4.0 DESIGN DEVELOPMENT

4.9 RESPONSE TO PLANNING FEEDBACK

HOPWOOD HALL COLLEGE, MIDDLETON CAMPUS, ROCHDALE ROAD, MIDDLETON, M24 6XH
Application Nos 24/00548/LBC & 24/00547/FUL

CONSERVATION CONSULTATION RESPONSE		
Conservation Officer	Catherine Fenghour	
Date	2 August 2024	
Application Reference	24/00547/FUL and 24/00548/LBC	
Address	Hopwood Hall College, Rochdale Road, Middleton, M24 6XH	
Proposal	Conversion of former chapel to provide education/teaching facility including internal and external repairs and internal works to provide classrooms and associated facilities, alongside external landscaping and the addition of one accessible parking space

PROPOSED PLAN

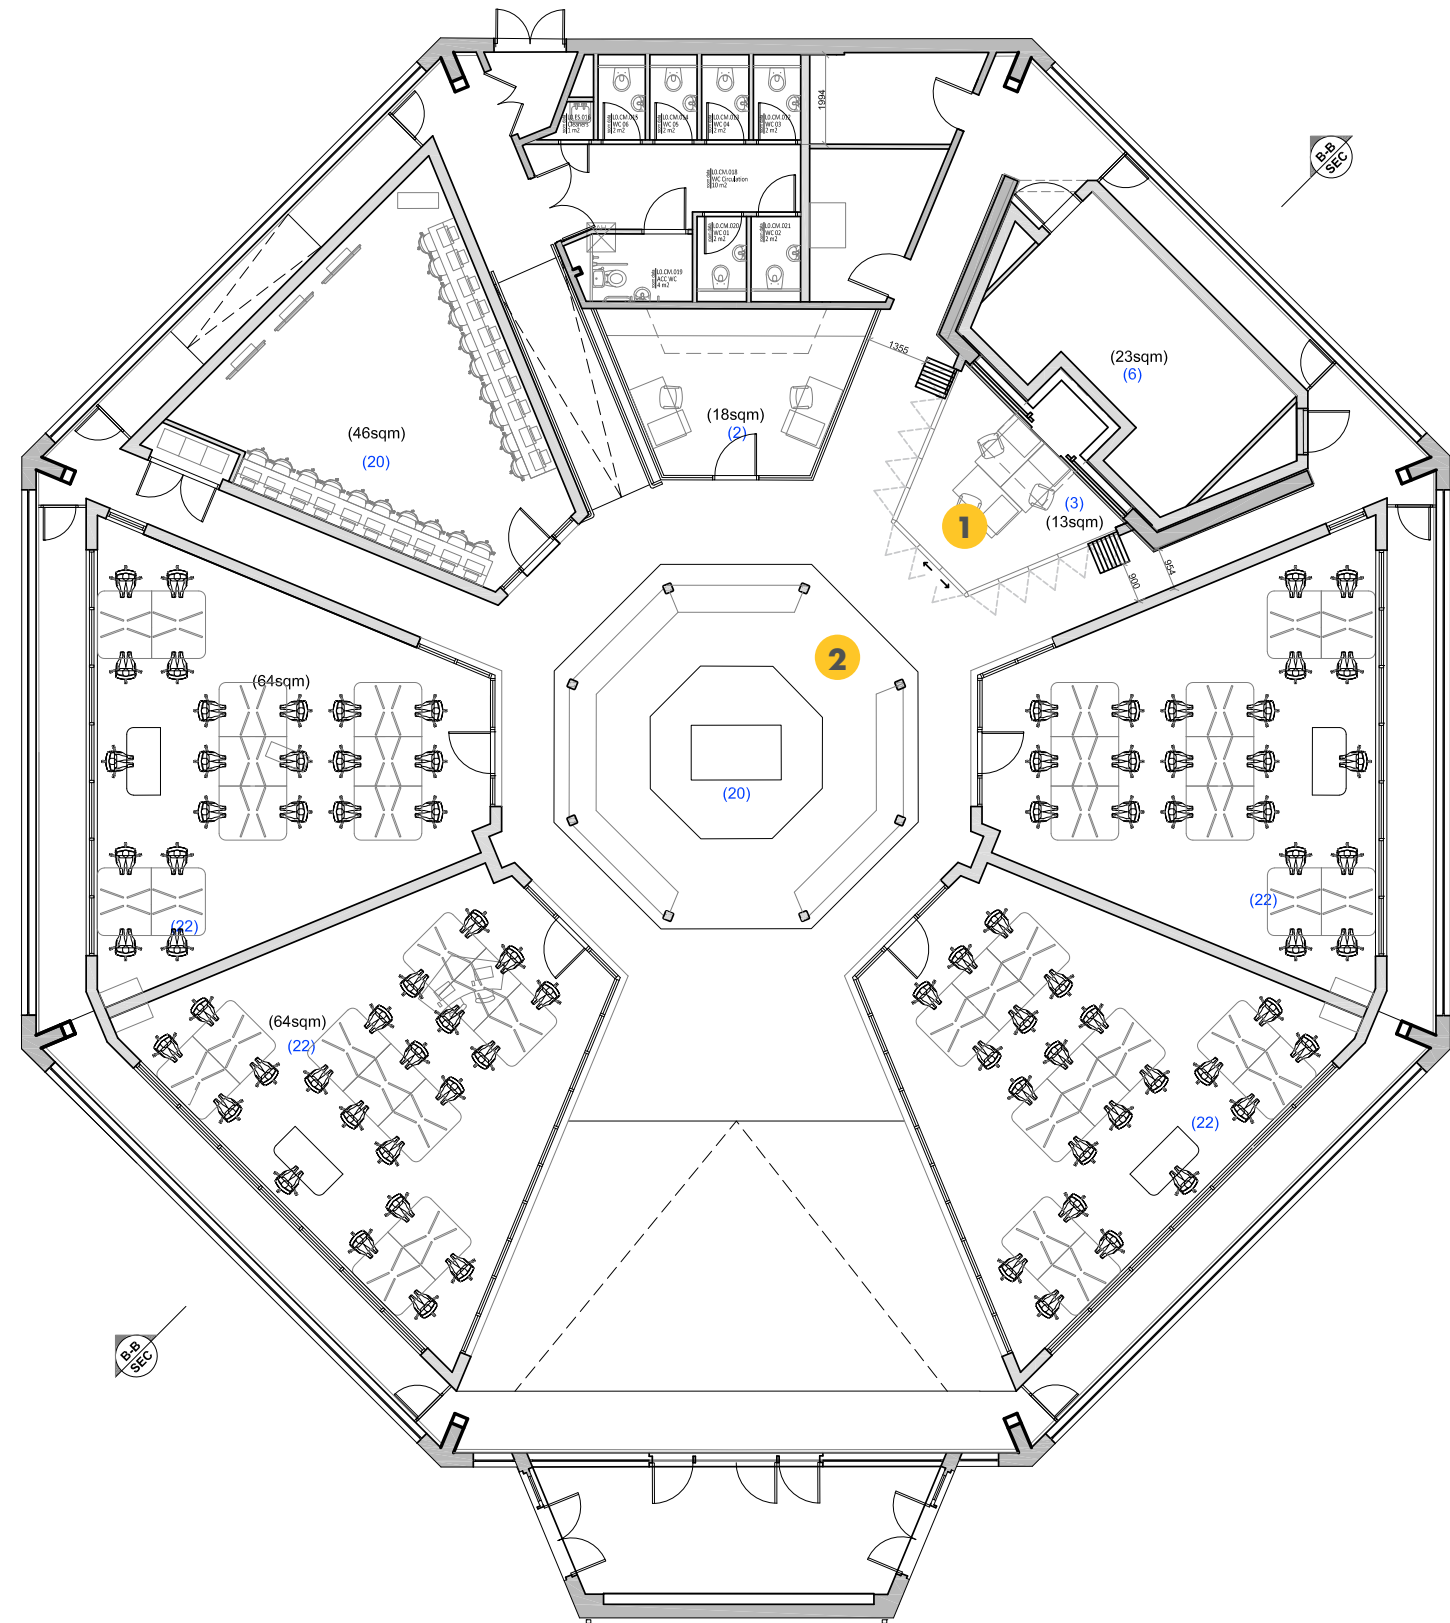
We do however have concerns about proposals to enclose the Blessed Sacrament chapel to create an immersive VR space and staff office. We feel that this chapel should be left unenclosed and remain

Committee members also discussed the proposed raising and covering over of the floor. Members appreciated the desire to achieve level access and had no objections to the proposal in principle. Members asked for reassurance however that the raised floor would be fixed in a way which does not cause damage to existing original floor finishes.

It is proposed that the new raised access floor will be adhered to the existing sub-floor on the basis that this will result in less damage to the historic fabric when compared to mechanical fixings.

- 1 Bi-folding doors to Office
- 2 Sanctuary area amended
